Butler Subdivision

Weber County, Utah

Butler Subdivision
PART OF THE NW 1/4 OF SECTION 32, T.6N., R.2W., S.11B & M., U.S. SURVEY
WEBER COUNTY, UTAH

Preliminary Design

Sheet	1
1	Sheets

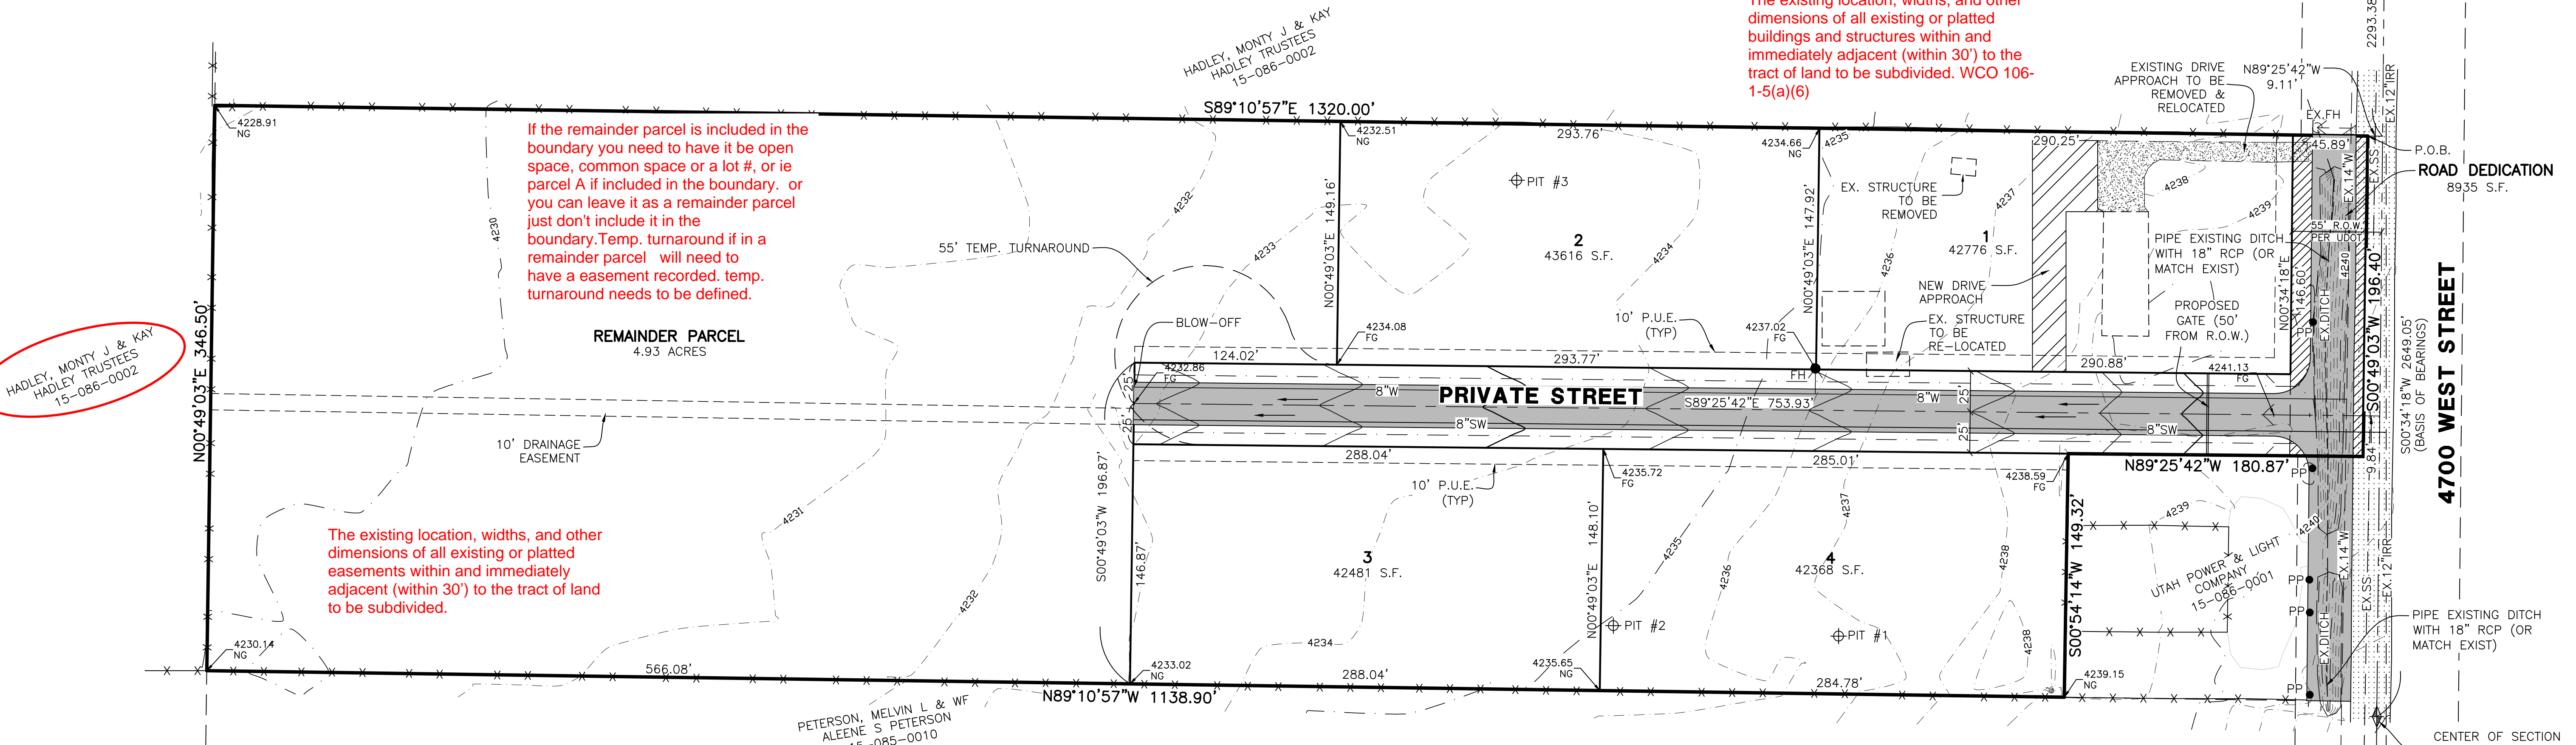
The existing location, widths, and other dimensions of all existing or platted buildings and structures within and immediately adjacent (within 30') to the tract of land to be subdivided. WCO 106-1-5(a)(6)

If the remainder parcel is included in the boundary you need to have it be open space, common space or a lot #, or ie parcel A if included in the boundary. or you can leave it as a remainder parcel just don't include it in the boundary. Temp. turnaround if in a remainder parcel will need to have a easement recorded. temp. turnaround needs to be defined.

The existing location, widths, and other dimensions of all existing or platted easements within and immediately adjacent (within 30') to the tract of land to be subdivided.

Boundary does not match record of deed either need to show measured vs record on plat to fix the overlap or quick claim the overlap to Utah Power

Subdivision name already exists need to rename

Subdivision Name approved by the county recorder.
Subdivision name in bold letters at top of sheet. General location of subdivision in bold letters at top of the sheet. The township, range, and quarter section of the subdivision in bold letters at the top of the sheet. Date of the survey noted in the heading (Meaning the date, year and month the survey markers were placed). WCO 106-1-5(a)(1); WCO 106-1-8(c)(1)a; UCA 17-27a-603(1)(a)

The individual or company names and addresses of the engineer and land surveyor of the subdivision,
